# Agenda Item 8

Vale of White Horse District Council – Planning Committee – 04 December 2011

<b>APPLICATION NO. APPLICATION TYPE REGISTERED PARISH WARD MEMBER(S)</b>	11/01520/FUL and 11/01521/CON Major 21 July 2011 Wantage Cllr John Morgan, Cllr Charlotte Dickson and Cllr Fiona Roper
<b>APPLICANT SITE PROPOSAL</b>	Berkeley Homes Ltd Land to the rear of 46 Newbury Street, Wantage Demolition of 46 Newbury Street and erection of 23 units comprising 19 houses and four flats with 40% affordable housing.
<b>AMENDMENTS GRID REFERENCE OFFICER</b>	Received 4 October 2011 439836 187584 Laura Hudson

Drawing Title:  
 Proposed  
 Site Plan

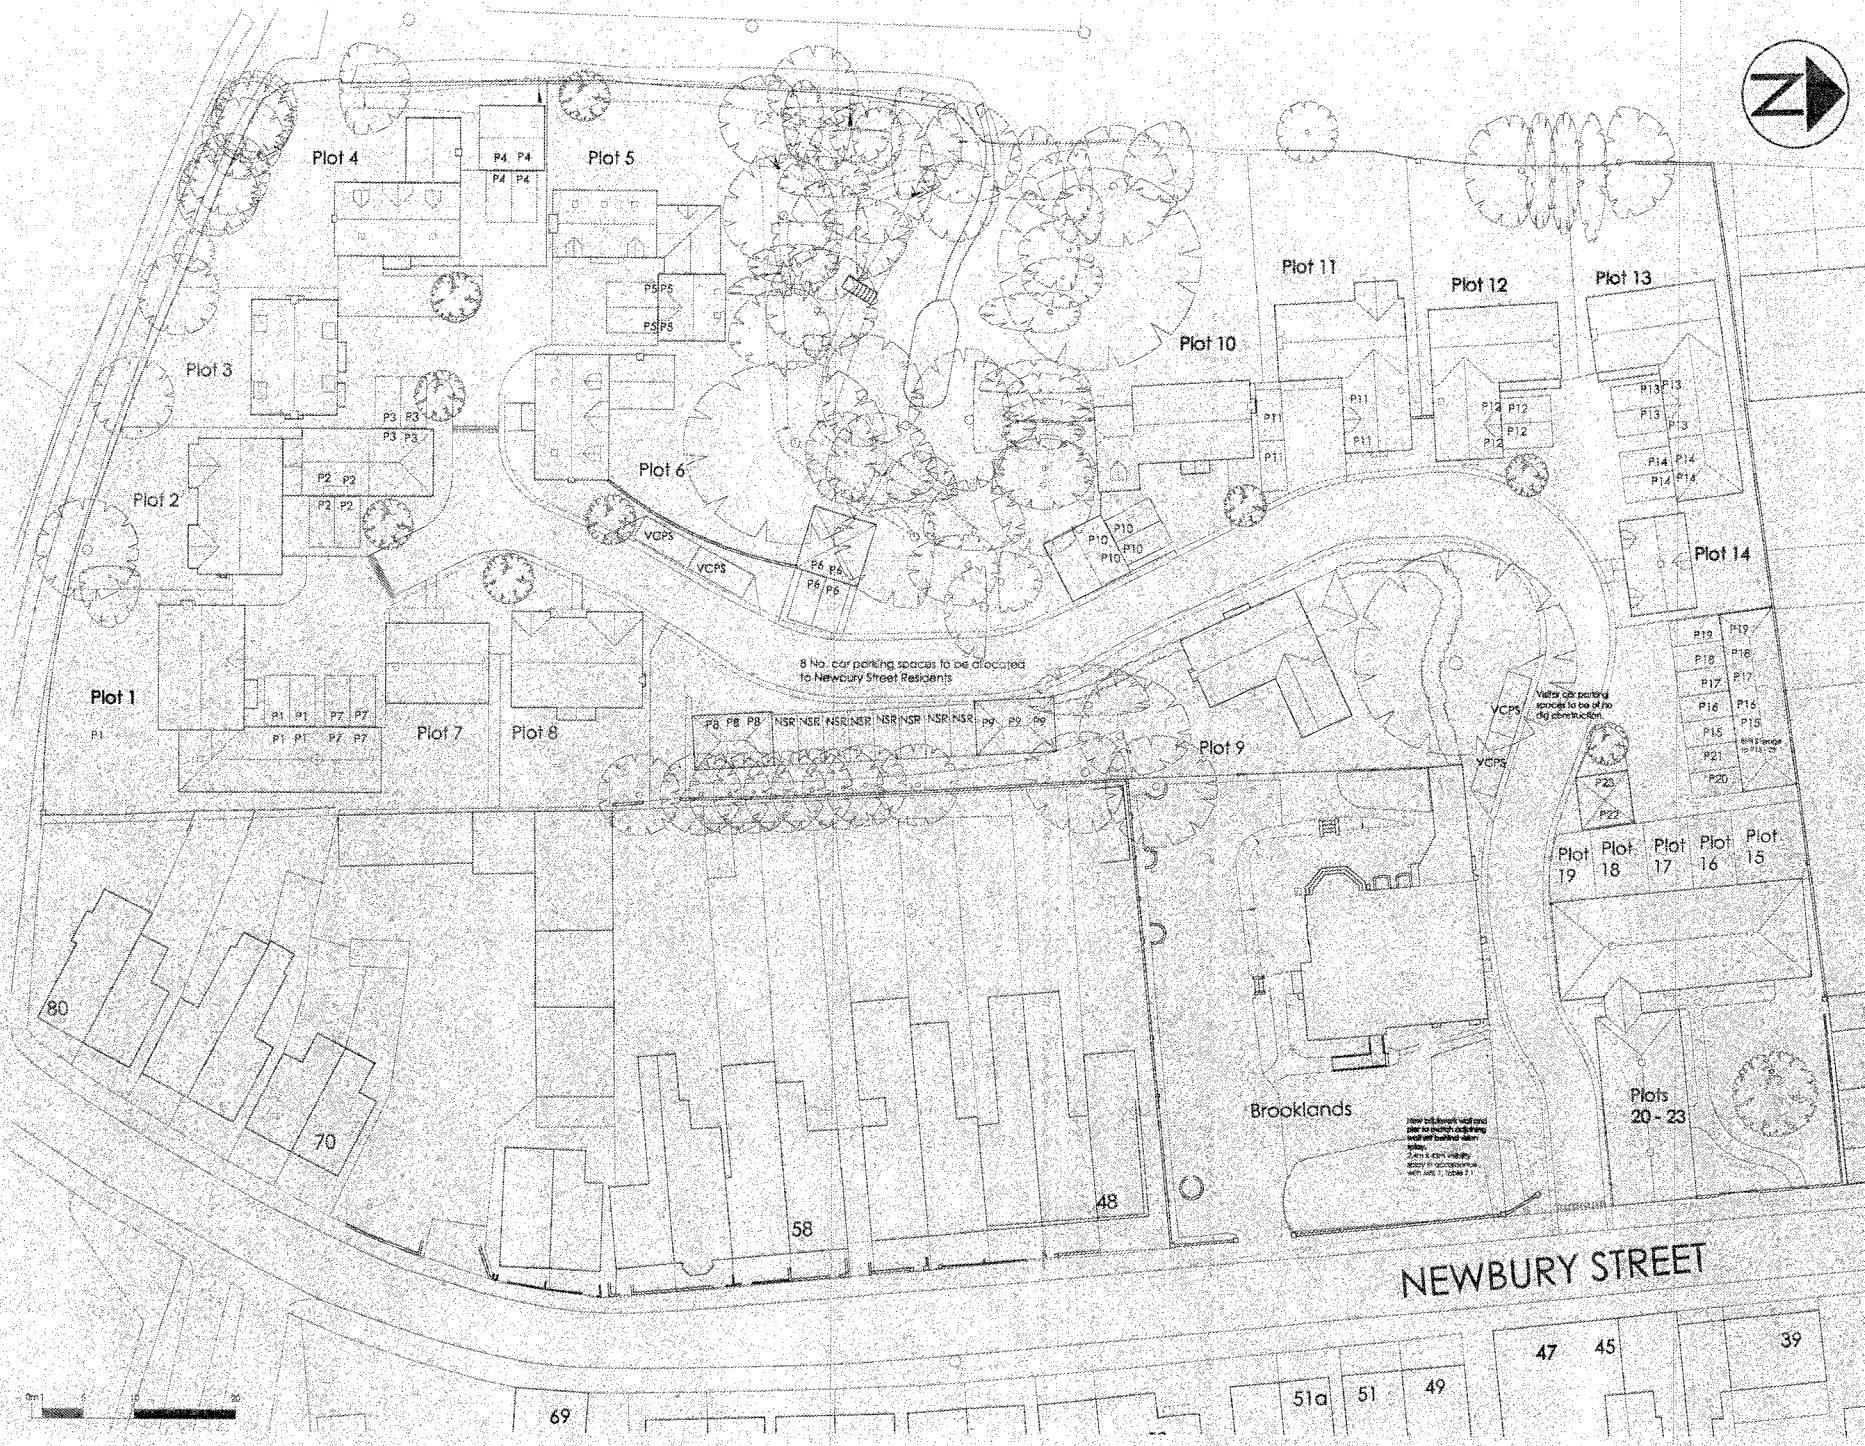
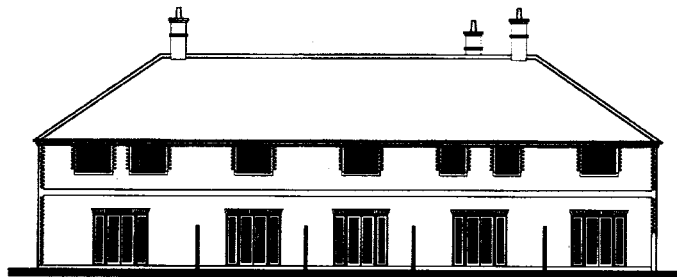
- 3.3 Conservation Officer – no objections in principle. Any further comments will be reported at the meeting.
- 3.4 Architects Panel – “Proximity of 20 – 23 too close to road (internal road) needs a footpath minimum – possibly provide front door access from new courtyard. Bin storage needs to be carefully considered. Overall scheme is random arrangement – should consider public spaces and groupings and vistas. Front boundary treatments and landscapes also need re-thinking. Largest house badly positioned. Plot 14 too close to road and also roof pitch too steep. 12 too close to road and some garage blocks too intense. Defer for negotiation.”  
(The plans have been amended to take account of these comments, including altering the layout and redesigning plots 9 and 14)

Concerns raised by the architects panel over the layout and design of some of the units have been addressed in the amended plans, including the access arrangement to plots 19 – 23 at the front of the site. This part of the scheme has been designed to reflect the character of the adjacent listed almshouses, both in terms of their detailing and their location fronting the street.

- 2.4 The application proposes off street parking and garaging for all of the new dwellings, plus some car parking provision for existing dwellings in Newbury Street who currently park on the site.
- 2.5 Amended plans have been received to address concerns raised by the architects panel in relation to the overall layout, the design and layout of plots 19 – 23, and the design of plots 9 and 14.
- 2.6 The site plan and extracts from the application drawings are **attached** at appendix 1.
